Model: NAD 30S/30/40		Date: 31-May-98	No: MA230001a												
Subject: China/Taiwan Version Information		Prepared by: S. Tomoe													
From: Technical Service Department.															
Classification:

The China and Taiwan version are going to be produced from June 1998. This RTB clarifies the differences between other Ricoh versions and China/Taiwan versions.

Model: NAD 30S/30/40		Date: 31-May-98	No: 3
Subject: Service Manual Corrections		Prepared by: Y. Furuya	
From: Technical Service Department.			
Classification:	<input type="checkbox"/> Troubleshooting	<input type="checkbox"/> Part information	<input type="checkbox"/> Action required
	<input type="checkbox"/> Mechanical	<input type="checkbox"/> Electrical	<input checked="" type="checkbox"/> Service manual revision
	<input type="checkbox"/> Paper path	<input type="checkbox"/> Transmit/receive	<input type="checkbox"/> Retrofit information
	<input type="checkbox"/> Other (      )

A230i704.wmf

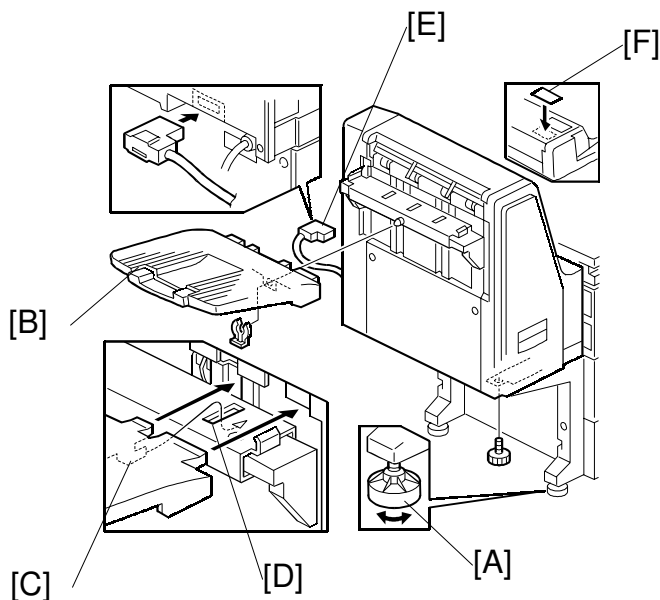
**6. 3.12 1000-SHEET FINISHER INSTALLATION    page 3-46**

- Delete step 5 and modify illustration A230I704.wmf (see the attached illustration).
- Add the following step after step 13 on page 3-47 and modify illustration A230i706.wmf (see the attached illustration).

A230i754.wmf

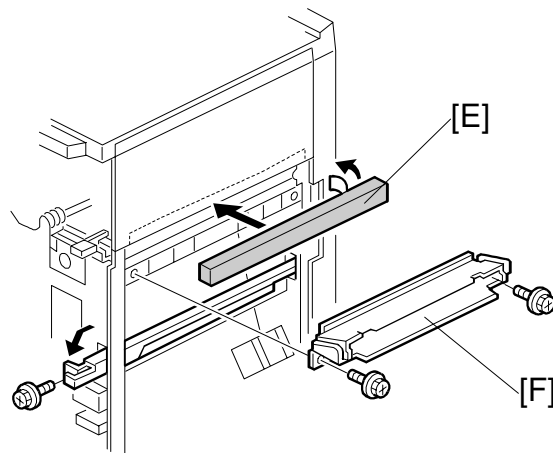
## 7. 3.13 3000-SHEET FINISHER INSTALLATION page 3-48

- Change the step from 5 to 8
- Incorrect -
- 5. Attach **two** lower grounding plates .....
- 6. **Cut away a part of the main power switch cover [E].**
- 7. Attach the cushion [F] to the plate as shown.
- 8. Install the entrance guide plate [G] (2 screws).
- Correct -
- 5. Attach **one** lower grounding plate .....
- 6. Attach the cushion [E] to the plate as shown.
- 7. Install the entrance guide plate [F] (2 screws).
- Change illustrations A230I754.wmf and A230I755.wmf.

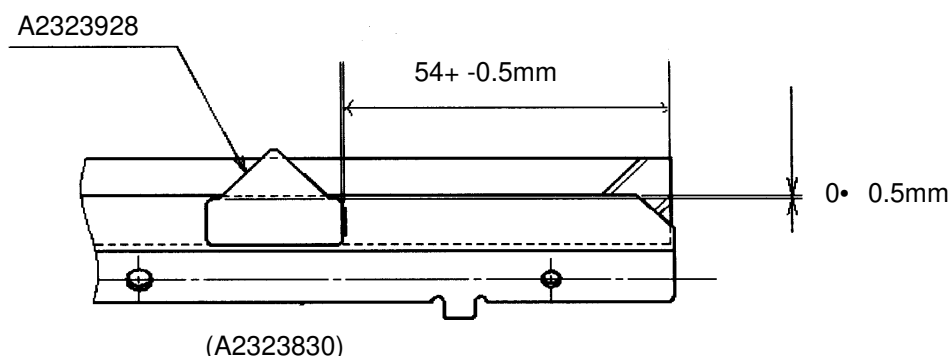
Toner overflow is detected prematurely.

1. Install the Toner Guide Mylar (#A2323928) on the transfer belt cleaning blade.

The Toner Guide Mylar will prevent the used toner from passing the toner overflow sensor.

2. Replace the old type blade with the new type blade (#A2323830) which has the Toner Guide Mylar.

## Countermeasure:

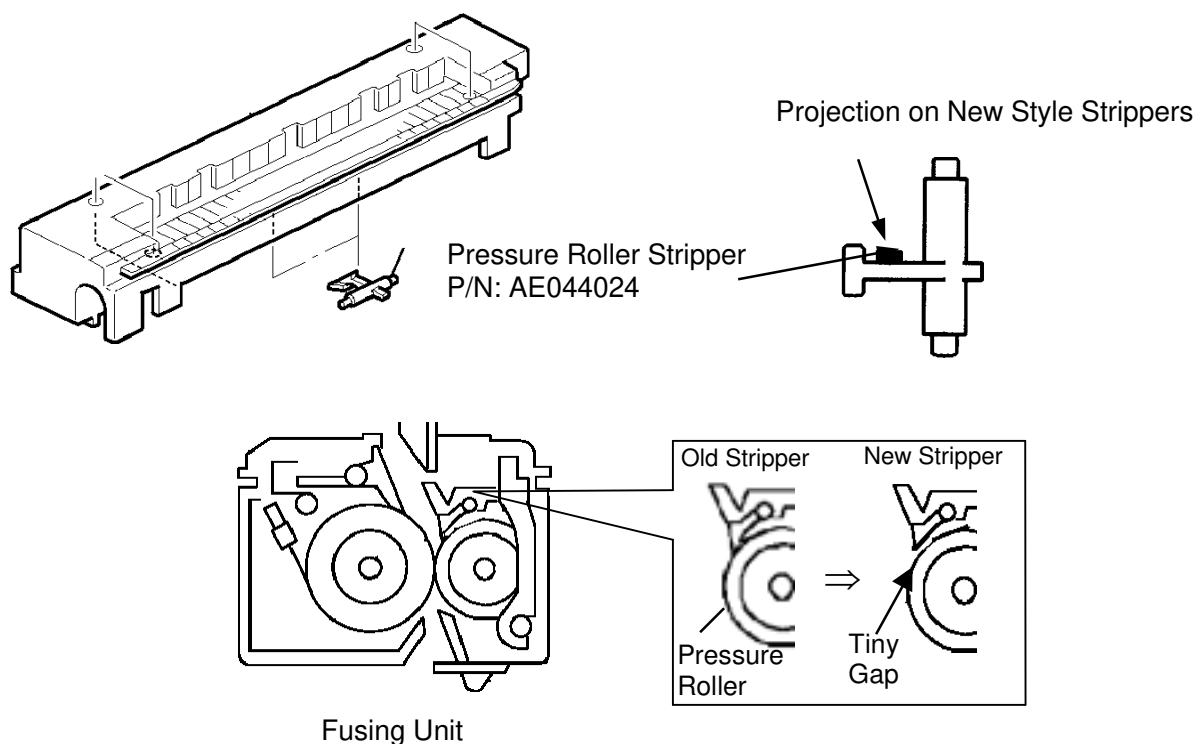
The pressure roller stripper has been modified by changing the lead edge angle. This modification is to make a tiny gap between the stripper edge and the roller surface.

The part number has not been changed. The new style stripper has a projection to make a visual difference from the old style stripper. The starting serial number of the machines with the new style stripper will be added as soon as it is available.

Replace the strippers to the new style ones and ask customer to check the fusing section by opening the right side cover when a paper misfeed occurs.

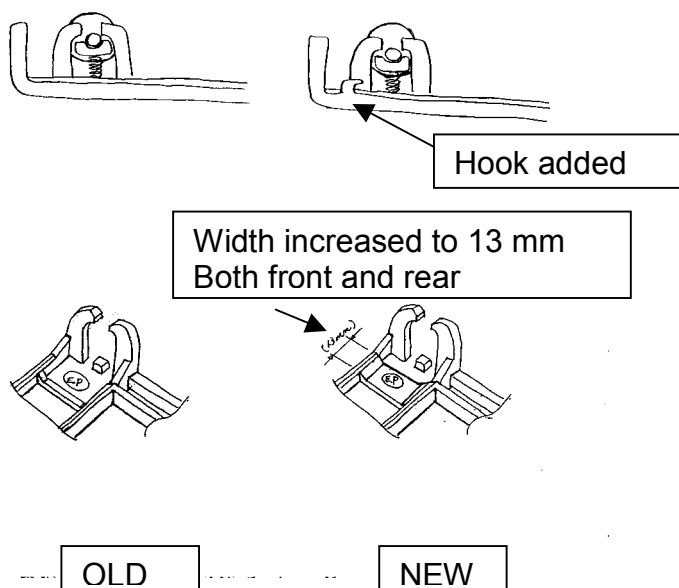
The upper fusing entrance guide is deformed by heat, and the hook section on the roller bushing expands so the roller bushing is no longer secured.

The following modifications were implemented to prevent deformation caused by heat to the upper fusing entrance guide:

1. A hook has been added ***to the entrance guide*** to prevent deformation.
2. The width of the plate near the point where the fusing cleaning roller is attached has been increased to 13 mm.
3. ***A 4 mm x 3 mm cutout has been added to the fusing unit frame (A2324051) to accommodate the hook added to the entrance guide.***

**SOLUTION 2:**

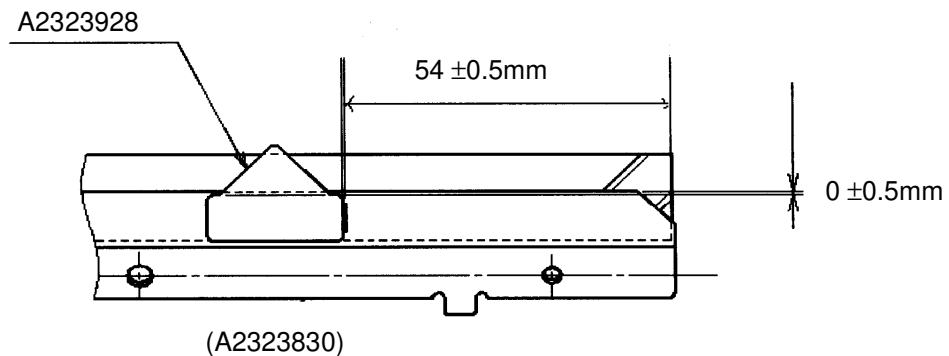
*To prevent toner from adhering to the sensor surface in the transfer unit before the case is full, a waste toner divider (mylar) has been added on the back of the cleaning blade. However, as noted in the explanation below, toner may still adhere to the surface of the sensor.*

1. Install the Toner Guide Mylar (#A2323928) on the transfer belt cleaning blade. This mylar will prevent the used toner from passing by the toner overflow sensor.

2. Replace the old type blade with the new type blade (#A2323830) which has the Toner Guide Mylar.

① : Entrance Seal Ass'y

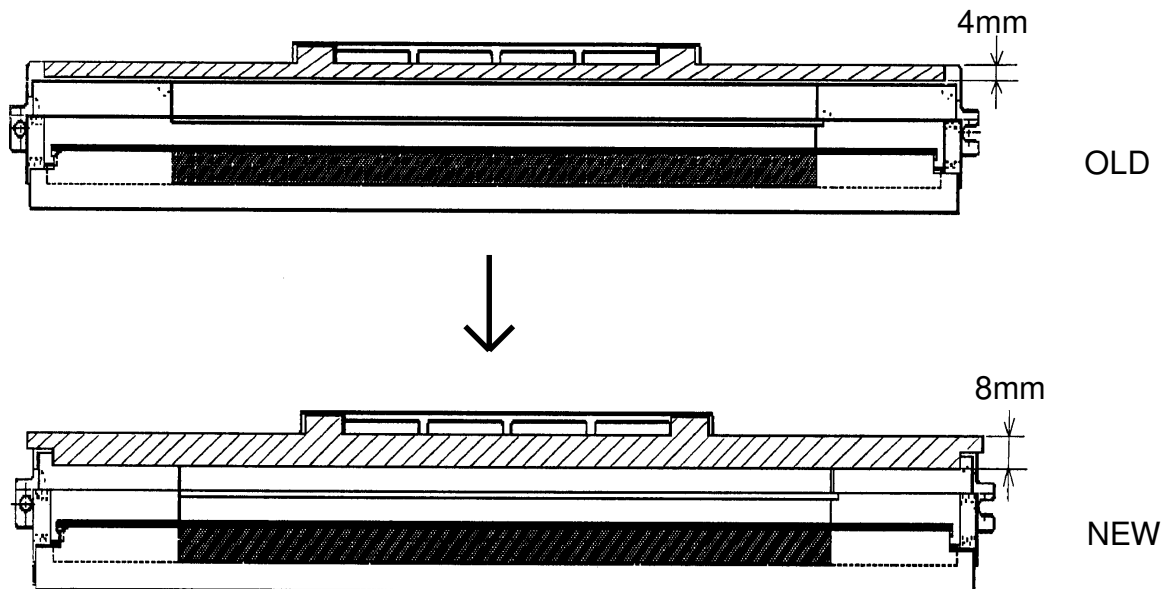
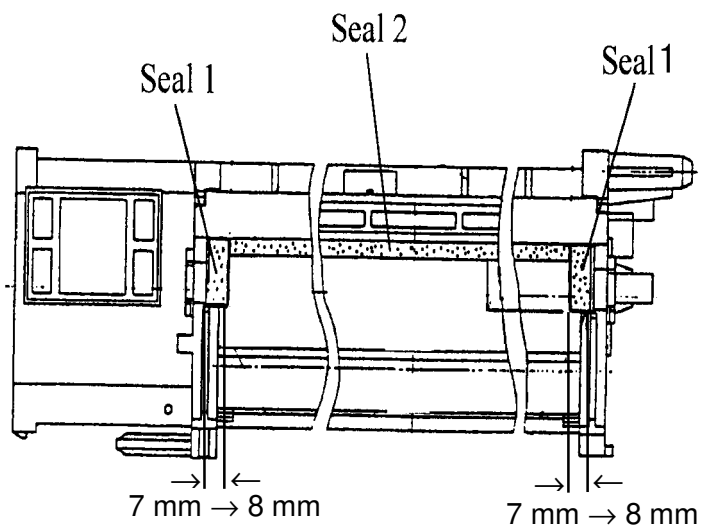
② : The width of seal 1 has been changed from 7 mm to 8 mm.

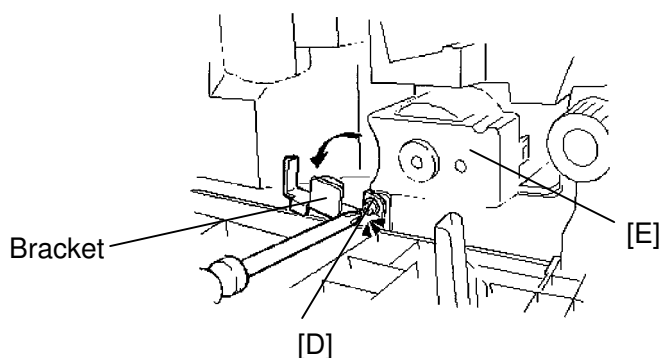
The method for securing the development unit has been changed, and is reflected in production runs from the end of May, 1999.

A bracket for securing the unit has been added.

**Fig. 1:**

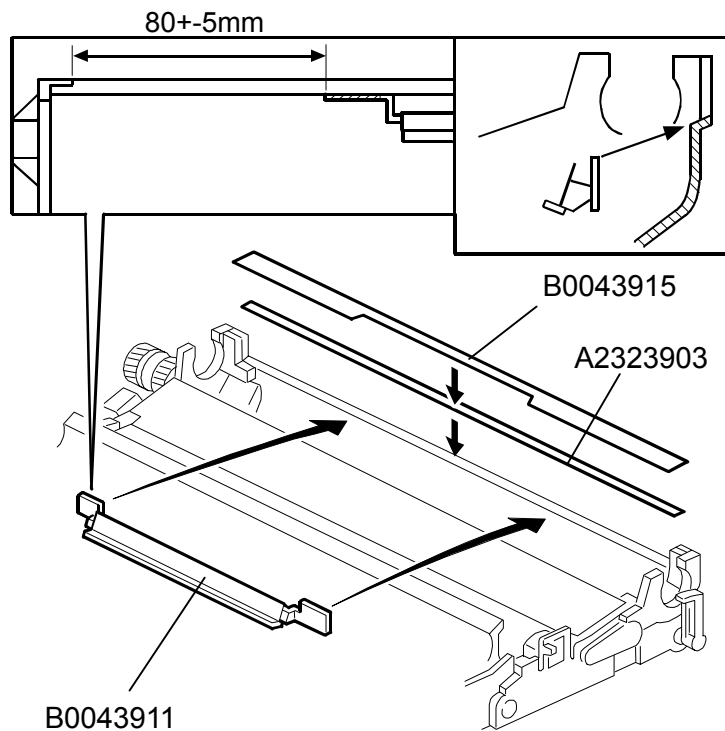
1. Remove the Transfer Unit, then the Transfer Belt and Cleaning Blade.
2. Peel off the old Entrance Mylar, then clean the surface of the attachment area underneath.
3. Clean out the inside of the unit thoroughly.
4. Attach the Remove Paper Dust Mylar (B0043911) as shown in Fig. 1.
5. Attach the Tape – Entrance Mylar (A2323903) and Entrance Mylar (B0043915) as shown in Fig. 1.

**Fig. 2:**

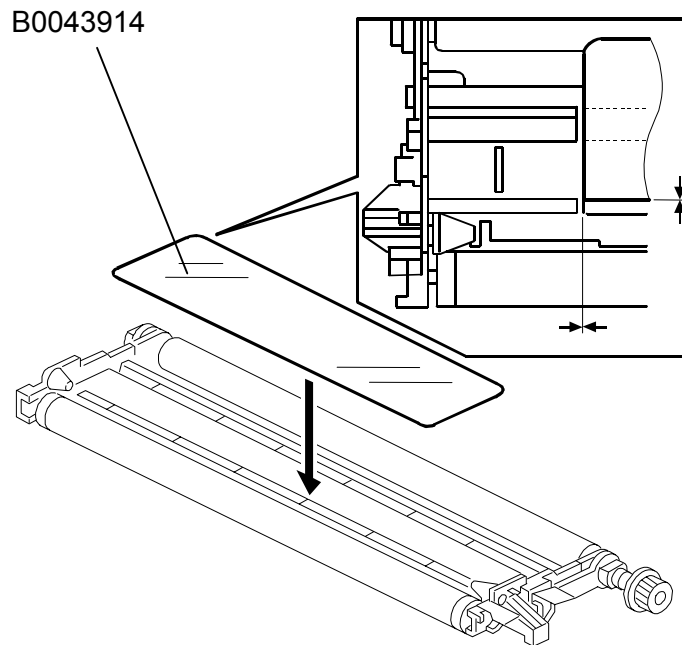
6. Attach the Mylar - Drive Roller Entrance (B0043914) to the Transfer Unit Frame, as shown in Fig. 2.
